*LUCAS COUNTY
PLAN COMMISSION
REPORT*

FEBRUARY 27, 2013

2. Z17-C341: Amendment to PUD for Lakeside at Fallen Timbers at 4623 & 4809 Lakeside Drive (Lots 35 & 36) (jl)

- Request - Amendment to PUD for Lakeside at Fallen Timbers
- Location - 4623 & 4809 Lakeside Drive (Lots 35 & 36),
Monclova Township
- Applicant - LCH Holding Co.
Don Ulrich and Brian McCarthy
3618 King Road
Toledo, OH 43617
- Engineer - Gregory Boudouris, P.E., P.S.
Engineers, Surveyors & Associates, LLC
5353 Secor Road
Toledo, OH 43623

PRELIMINARY DRAWING FOR LAKESIDE AT FALLEN TIMBERS WITHIN THE WATERSIDE PUD

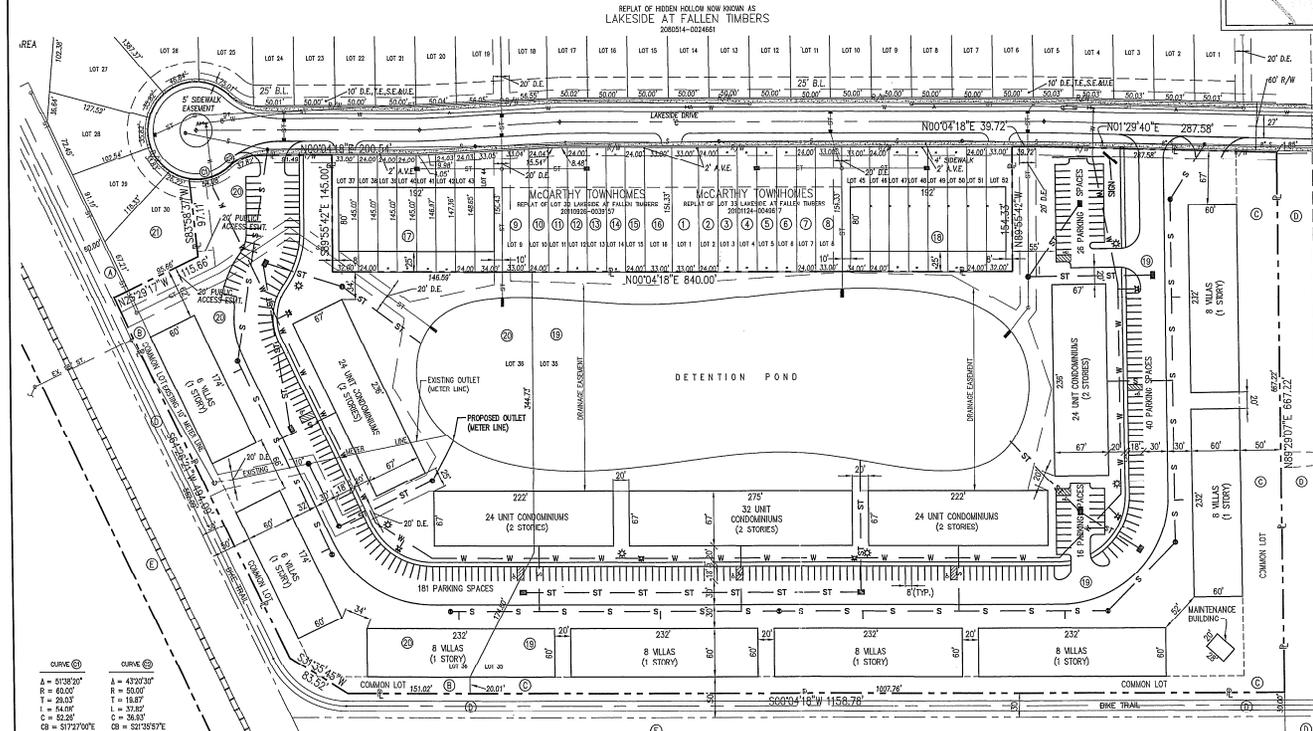
The plan includes a building and surface coverage of 39.86% of the parcel acreage, which is within the maximum of 40% per the zoning resolution. This number includes villa driveways that were left off the plan for display purposes. The plan does not detail the amount of usable, accessible and consolidated open space for the project. An analysis of the plan suggests that the detention pond (one third which may count towards open space) and the surrounding green space in the center of the project provide the required 15%. Consideration may be given to open space provided throughout the rest of the Waterside PUD, although no open space estimates were provided. Staff recommends that the applicant submit a revised plan that indicates all pervious surface and clearly identifies and calculates the 15% open space.

The project meets the parking requirements (two spaces per dwelling unit) by providing individual driveways and garages for each villa unit and 263 parking spaces for condominiums. It should be noted that the condominium parking spaces are provided at a reduced width of 8 feet instead of the standard 9 feet. The standard 9 feet offers adequate spacing between vehicles and reduces the likelihood of parking conflicts. Reconfiguring the proposed parking spaces to 9 feet may result in a loss of 29 spaces, bringing them under parking requirements (227 spaces vs. 256 required spaces). Staff recommends reconfiguring spaces to 9 feet in width and seeking a waiver for the number of required parking spaces, if additional spaces cannot be provided.

The landscape plan indicates tree plantings along the internal roadway, with denser screening along the side for the parking lots closer to Lakeside Drive, and includes a note indicating that the front of all buildings will be fully landscaped with a variety of plant material. No plantings are shown for the sides abutting the roadway of the parking lots closest to Lakeside Drive. Staff recommends additional screening along Lakeside Drive to minimize the visual impact from adjacent villa owners along with a revised landscape plan showing the location of all plantings.

2. Submit revised storm drainage calculations for review and approval due to the revised development plan and storm system layout from the previously approved 2006 site plan.

5. Six (6) foot wide walks adjacent to parking spaces shall be provided as per the previously approved site plan to control vehicular overhang.
 6. An eight (8) foot wide access path shall be provided from Lakeside Dr. to the Wabash North Fork Bike Trail in the platted 20 foot public access easement as per the requirement of the preliminary plat for this subdivision. A connection to this access path should be provided for the proposed development.

7. A pedestrian/bike connection to the bike trail should be provided at the northeasterly corner of the development per the previously approved plan.

8. Parking spaces are shown and labeled with a width of eight (8) feet. The township zoning resolution requires a minimum width of nine (9) feet.
9. Proposed one story villas:

- a. Nothing is shown for parking, walks, patios, etc. for the proposed buildings. Has this been included in the lot coverage calculations?
 - b. Rear yard drainage is not shown for the buildings and will be required. All proposed grading and swales along the adjacent property lines shall be labeled with proposed slopes, proposed spot elevations, and existing spot elevations along the property lines.

29. The plan shows a reconfiguration of a utility easement in order to accommodate a structure. A replat of Lot 36 will be required.
30. The proposed development is currently located on two separate parcels. The parcels shall be combined through the replat process in condition 29 or by filing an “Application for Combination” at the Lucas County Auditor’s office.

31. The proposed parking dimensions of eight feet do not meet the standard nine feet for optimal spacing and parking conflicts. The applicant will need: to provide additional spaces without exceeding coverage, reduce the number of units, or request a waiver with the township trustees or a variance with the board of zoning appeals for the number of spaces required.

32. The plan does not include all pervious surface for the project in the coverage calculation. A revised site plan should be provided to the township that includes all pervious surfaces so that the plan and coverage calculations match.

33. The project appears to meet the required 15% useable, accessible and consolidated open space through the detention pond and the surrounding greenspace in the center of the project. A revised site plan should be provided to the township that includes the amount and location of open space for the project. Consideration may be given to excess open space provided throughout the rest of the Waterside PUD, although no open space calculations were provided.

34. A revised landscape plan shall be submitted to the township that includes the following:
 - a. Screening along the northern side of the two parking lots abutting Lakeside Drive to reduce the parking lots visual impact on nearby residents.

- b. Detailed information and locations for all plantings along the frontage of the buildings.
